Butte Priority Soils Operable Unit (BPSOU) Unreclaimed Sites – Final Field Sampling Plan (FSP) #2; Unreclaimed Sites UR-24, UR-26, and UR-40.

# Butte Priority Soils Operable Unit (BPSOU) Unreclaimed Sites – Final Field Sampling Plan (FSP) #2; Unreclaimed Sites UR-24, UR-26, and UR-40.

# Re: Approval letter for the Butte Priority Soils Operable Unit (BPSOU) Unreclaimed Sites Final Field Sampling Plan (FSP) Submittal #2: Unreclaimed Sites UR-21, UR-26, and UR-40 (dated August 18, 2021)

Figure 1 Unreclaimed Site UR-24 Proposed Sample Locations Figure 2 Unreclaimed Site UR-26 Proposed Sample Locations Figure 3 Unreclaimed Site UR-40 Proposed Sample Locations

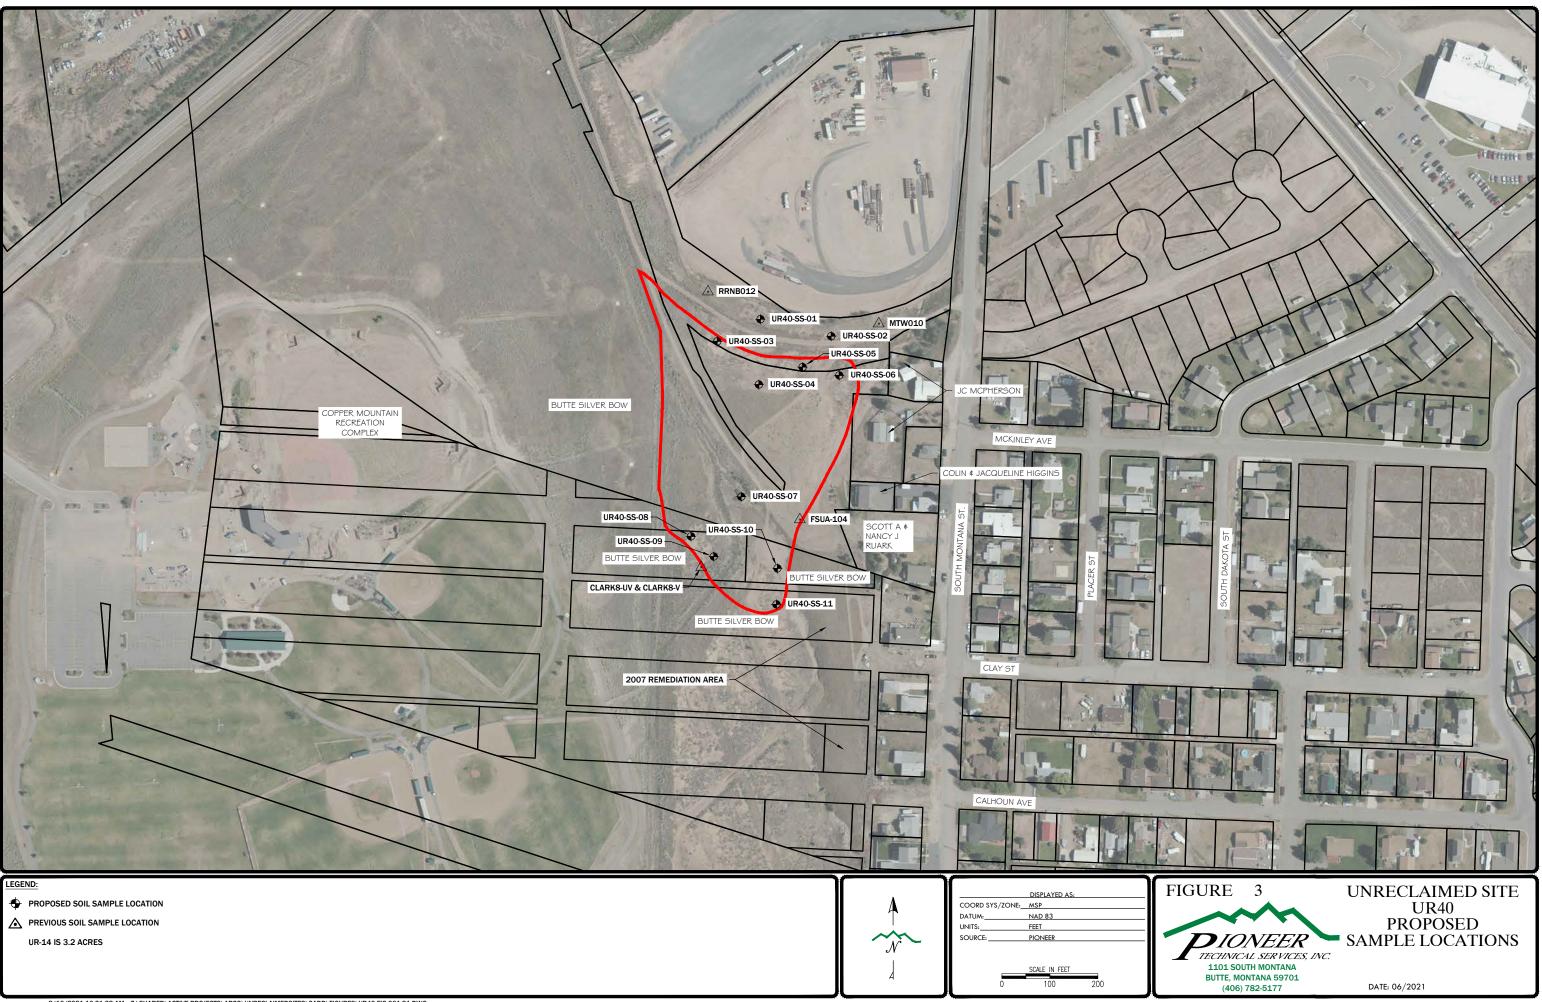
The U. S. Environmental Protection Agency (EPA), in consultation with the Montana Department of Environmental Quality (DEQ), is approving the *Unreclaimed (UR) Sites Final Field Sampling Plan (FSP) Submittal #2*. Please note that it is EPA's and DEQ's expectation that UR-26 site will be fully characterized, including an opportunistic sample(s) and sample(s) collected from waste/dredge piles that parallel the Grove Gulch stream. Please distribute this FSP submittal #2 as final.
